BID #24-26-D04
Sitework and Structural for Downtown Campus
Addendum One
Released 11/26/2024

ADDENDUM: Addendum One addresses a process to request to be added to a prime/sub list for this project, questions and clarifications, a revised bid form, and drawings for DLC and DTC.

**Rock Valley College
New Downtown Campus
Sitework and Structural
Bid #24-26-D04**

Architect's Project Number: 23-030

2 NORTH EAST FOUNDATION PLAN
 1/4" = 1'-0"

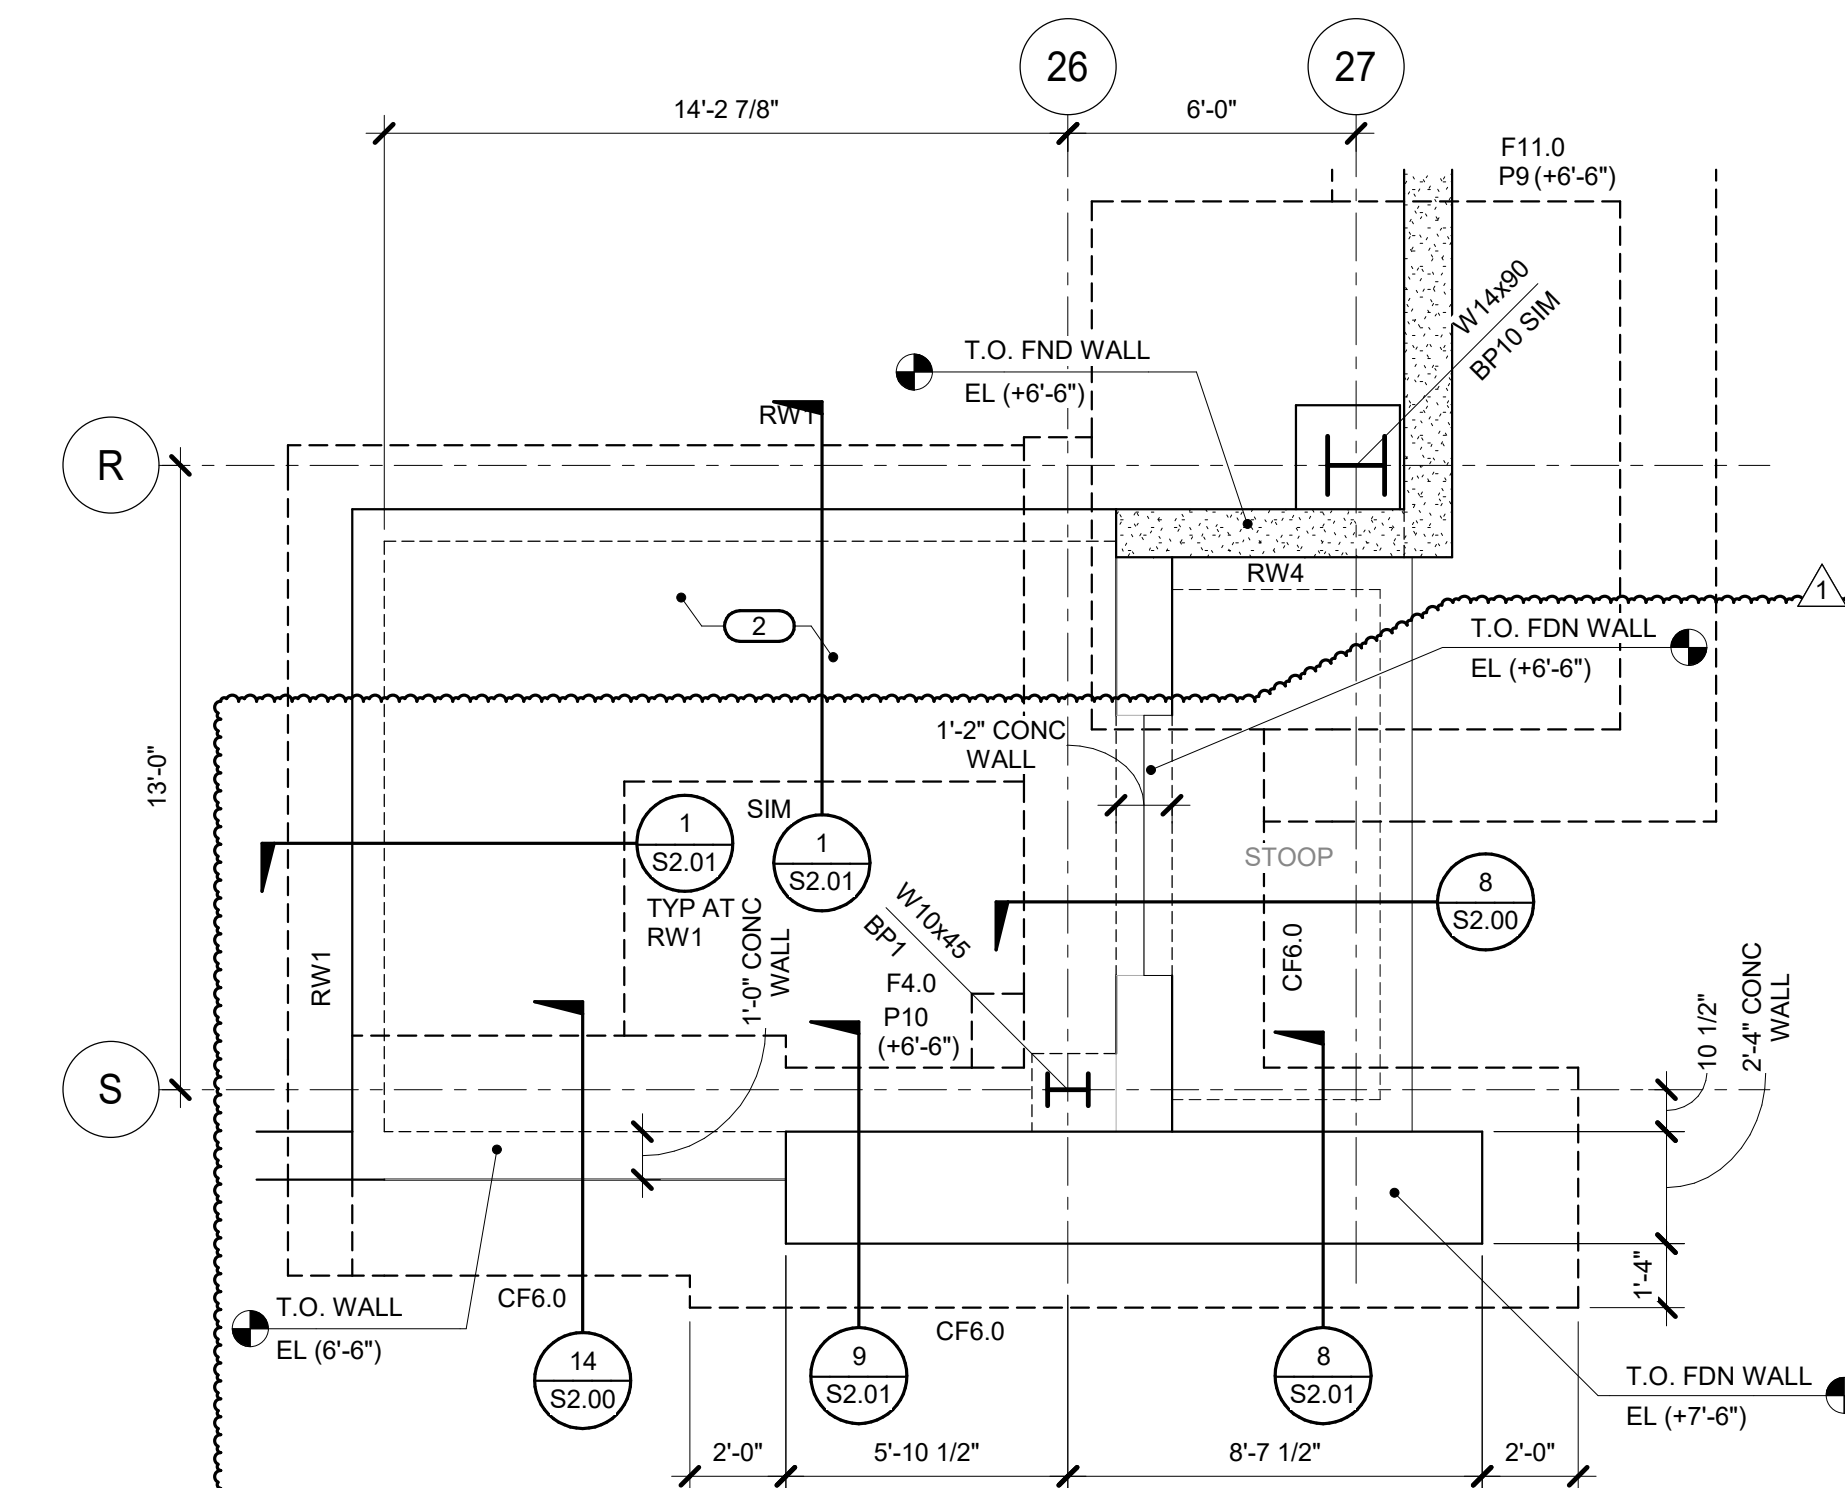
- B. Post-Installed Anchors updated to Hilti products.
8. Sheet S1.00
 - A. Retaining wall foundations updated as required for coordination between slab and stem wall.

- B. Details added at oversized feature walls at Grid M and Grid S.
9. Sheet S1.01
 - A. Detail cut added at edge of deck along Grid 25.
 - B. Details updated at wind girt across EV Lab – detail 14/S4.01 along Grid 23.

10 FOUNDATION AT PRECAST WALL
 3/4" = 1'-0"

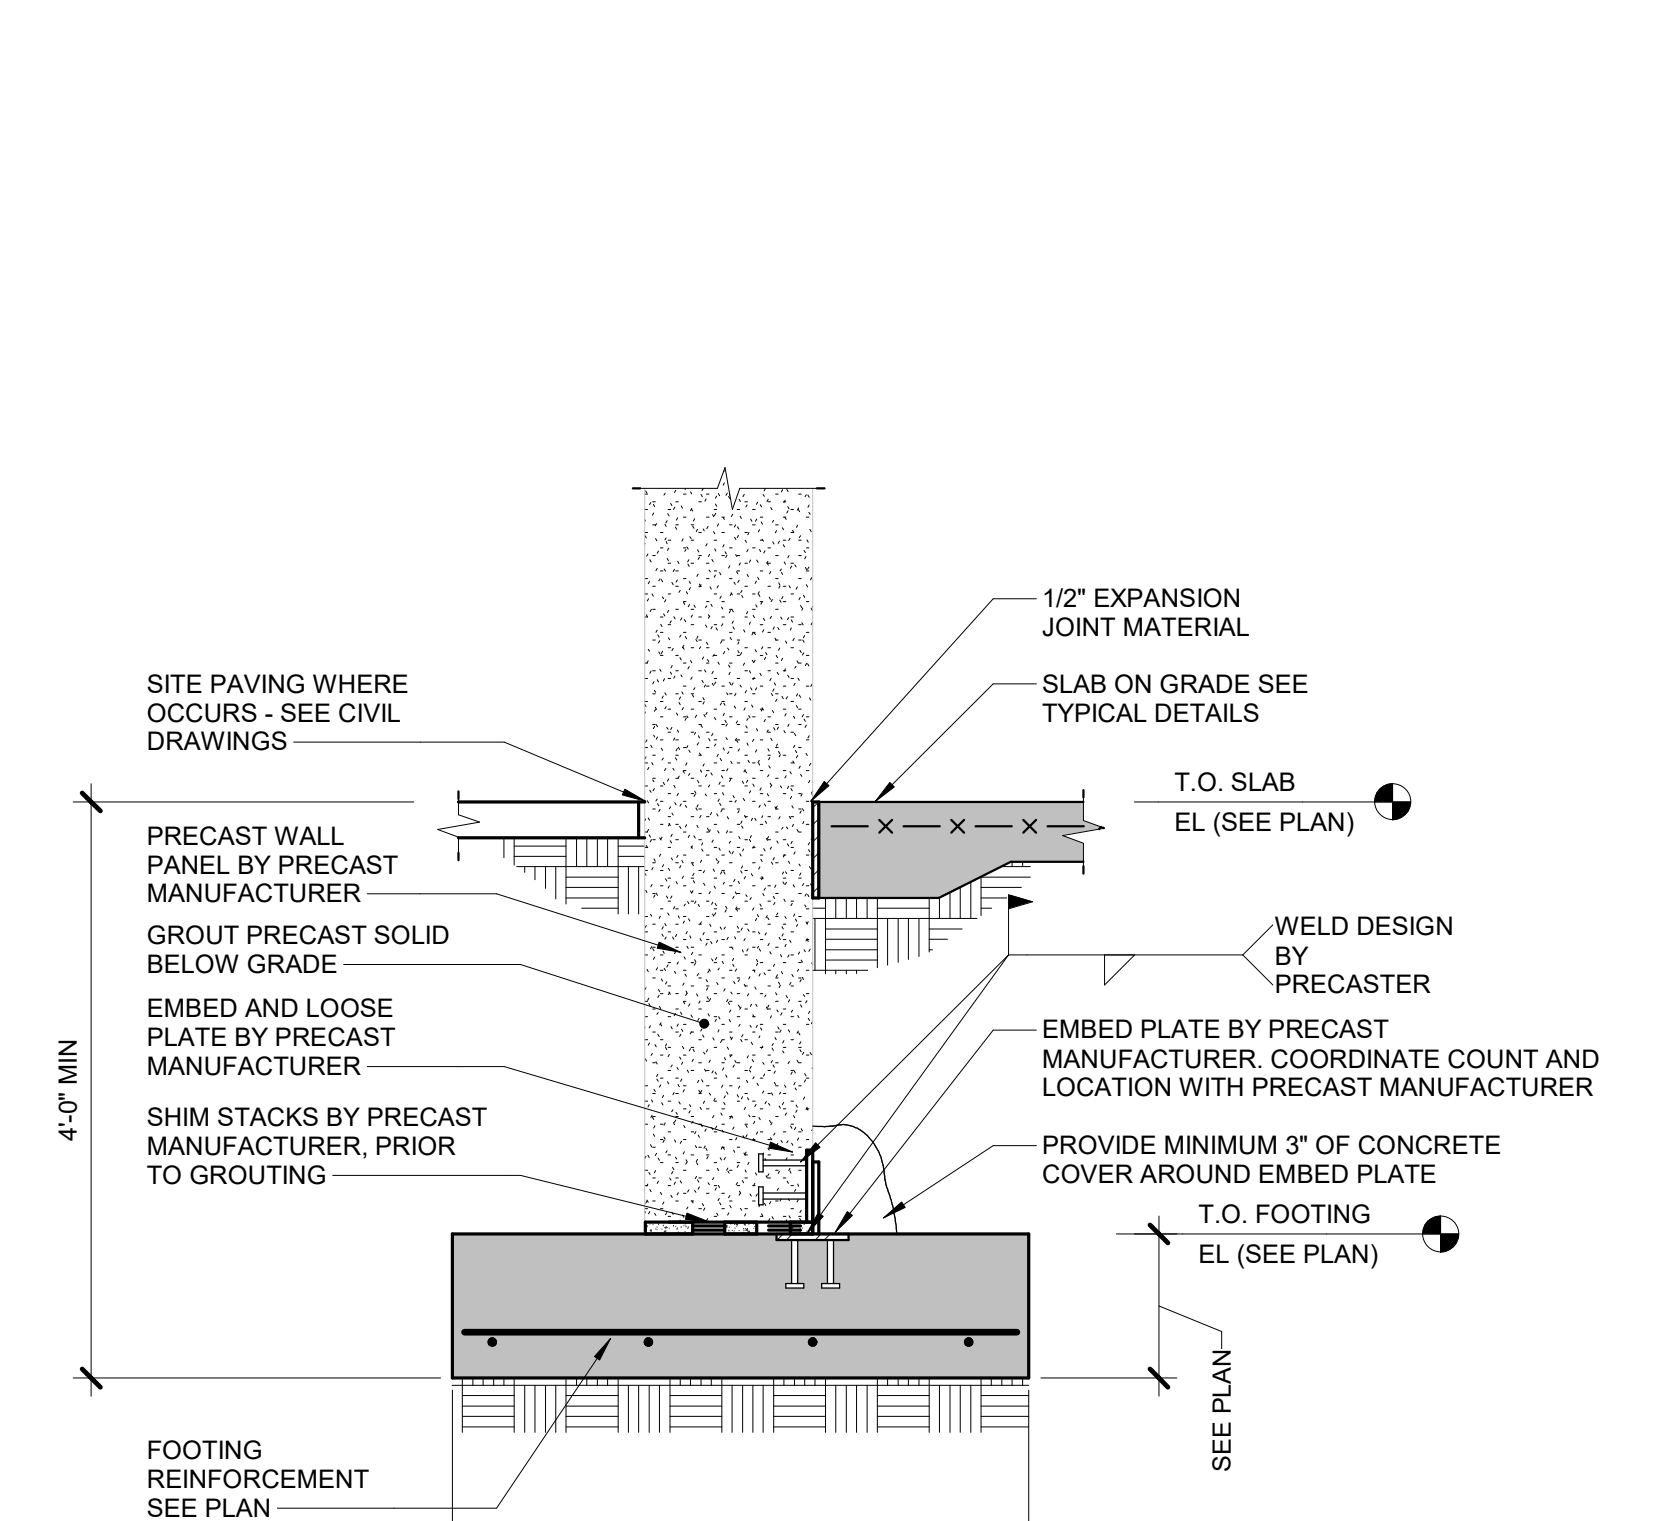
- B. Sump pit wall reinforcement detail reference updated.
 - C. Detail 14/S2.00 updated to reflect the reality of oversized stem wall. Foundation size and construction notes were added/updated to ensure that backfill is provided evenly either side of wall. In the event one side cannot be backfilled simultaneously as the other, this wall has been designed for a retaining condition.

8 OVERSIZE FOUNDATION WALL
 3/4" = 1'-0"

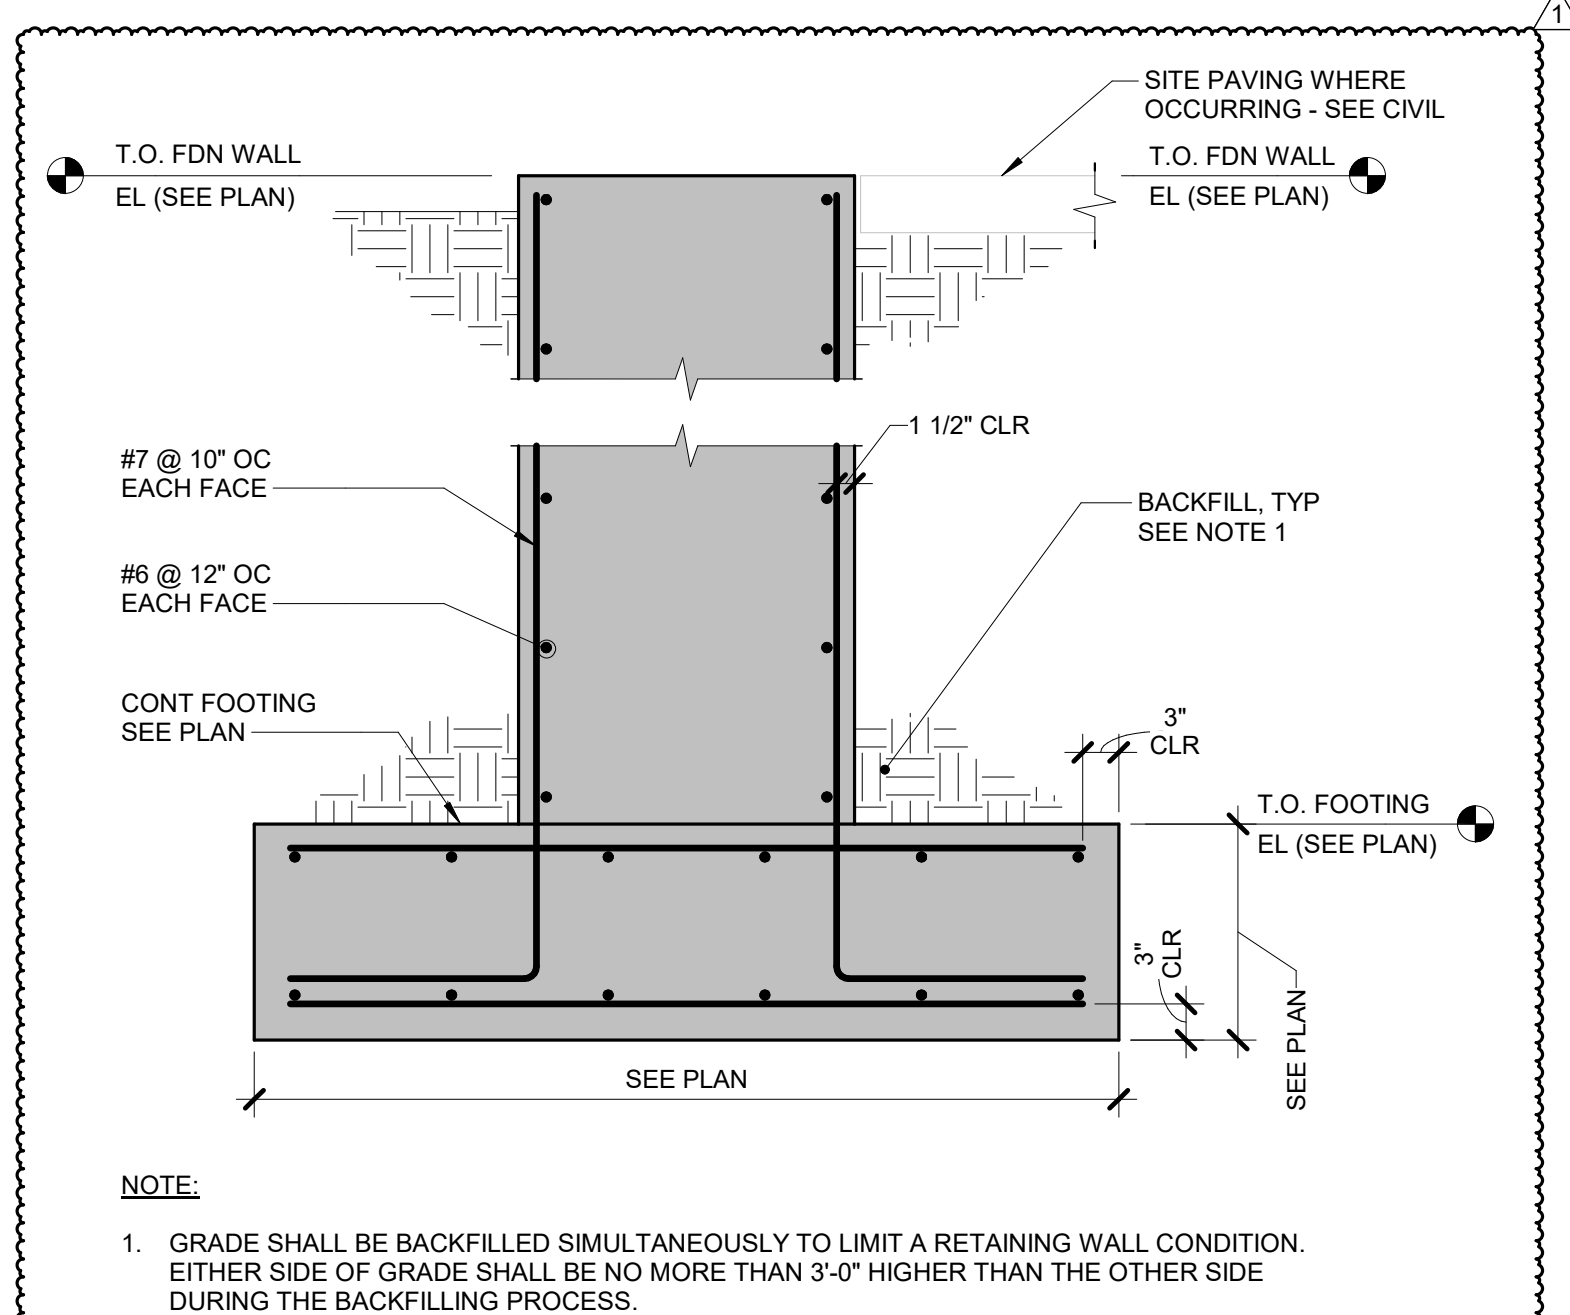
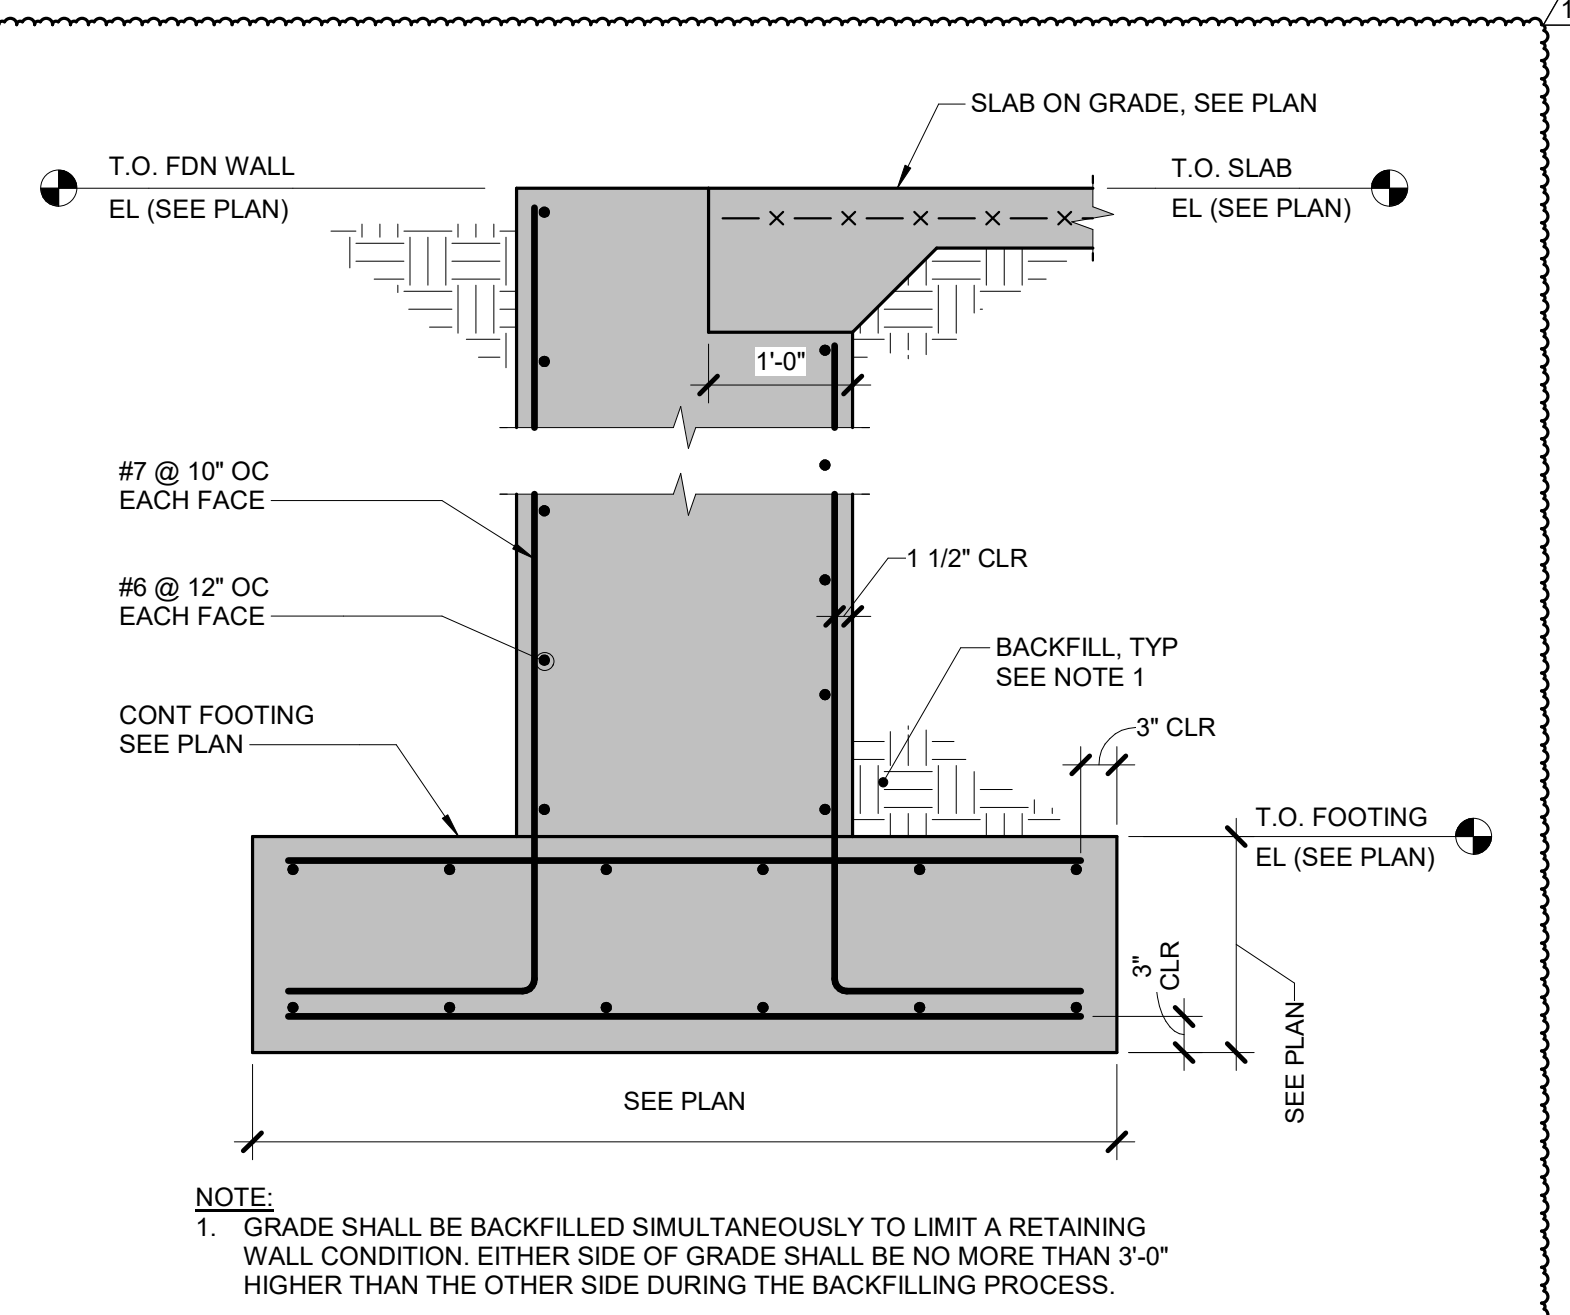
12. Sheet S2.01
 - A. Retaining wall dimension maximums added to details.
 - B. Elevator detail updated and mat slab footing depth reduced.
 - C. Details 8 and 9 were added at northeast and southeast oversized feature walls (see above notes on sheet S1.00).
